# HONDA

| Classification<br><b>AFTERSALES</b> | Number<br><b>AS 042/01 Pg 2/2</b> | Date<br><b>24/8/01</b> | Contact<br><b>MITCH KENNY</b> |

## REPAIR PROCEDURE CONTINUED

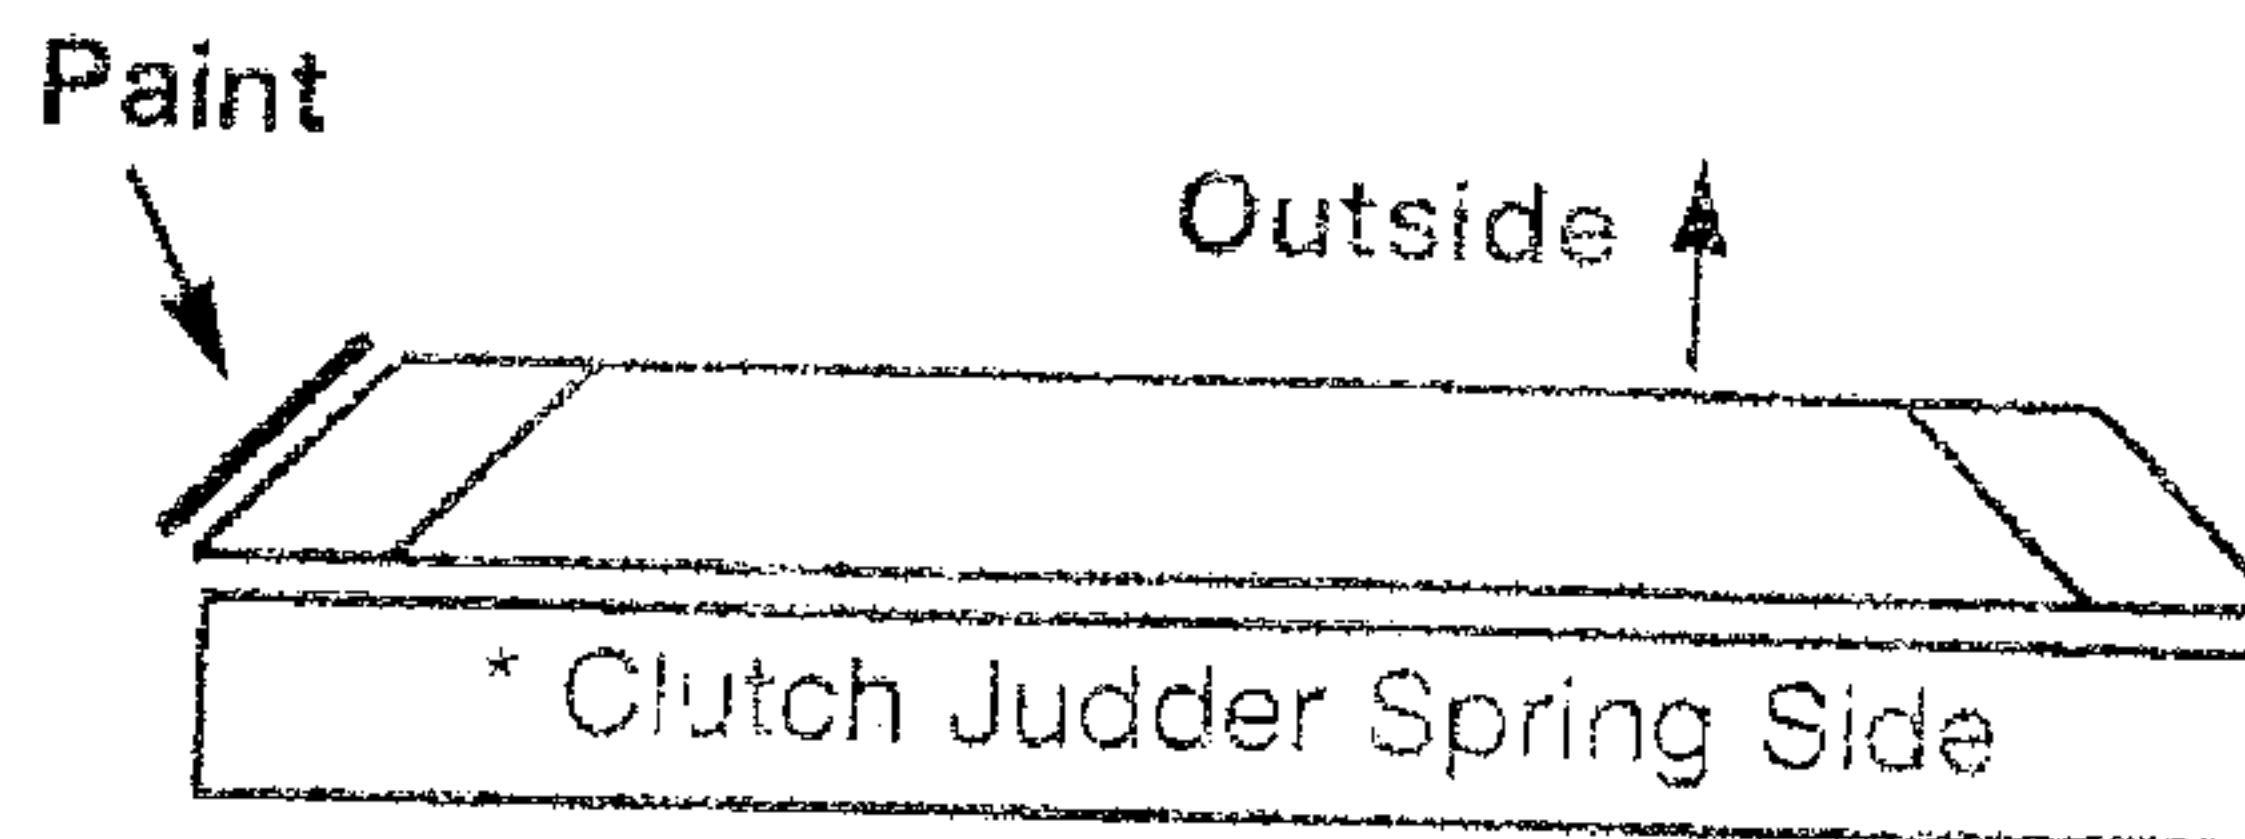
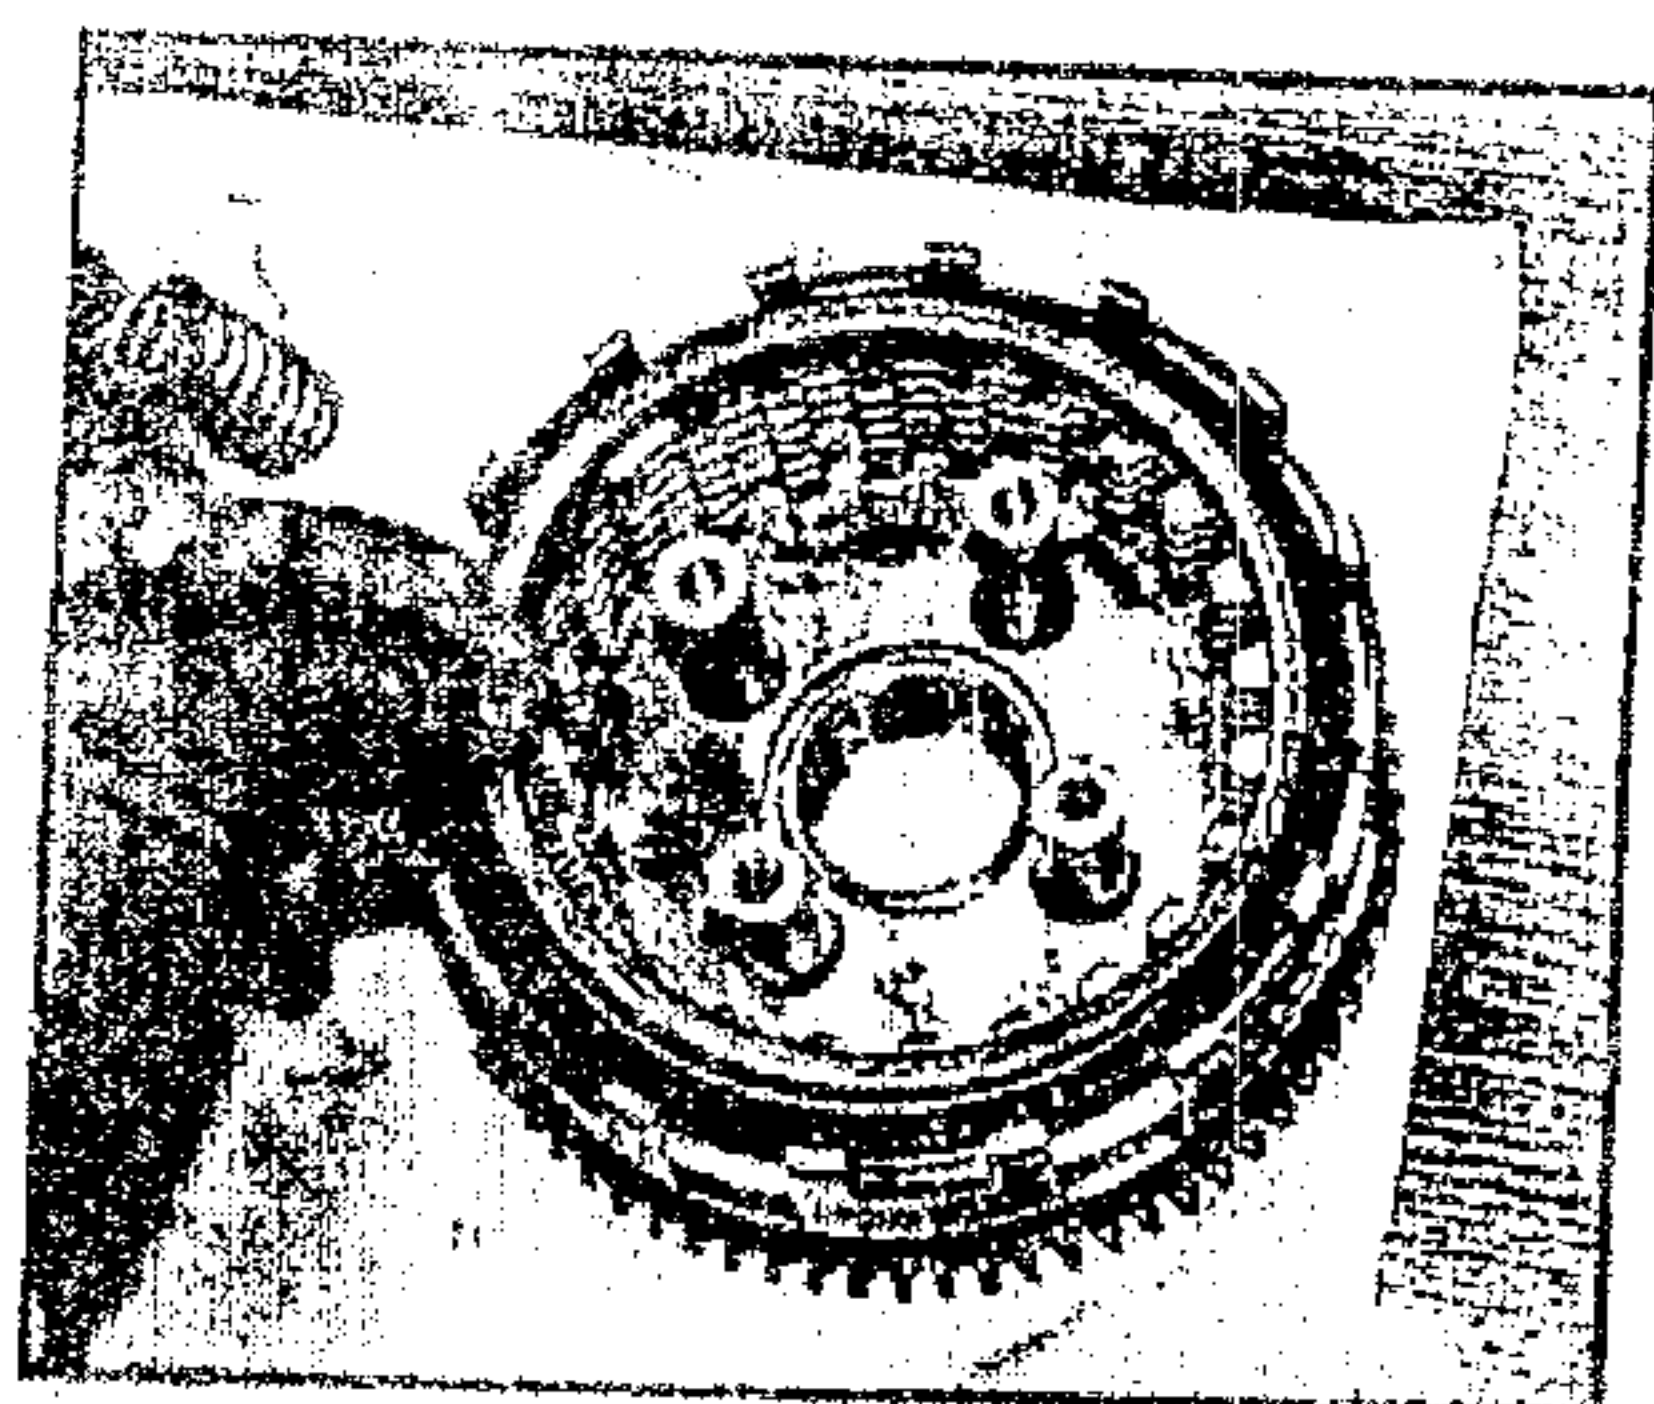
Install the judder spring and seat as shown below
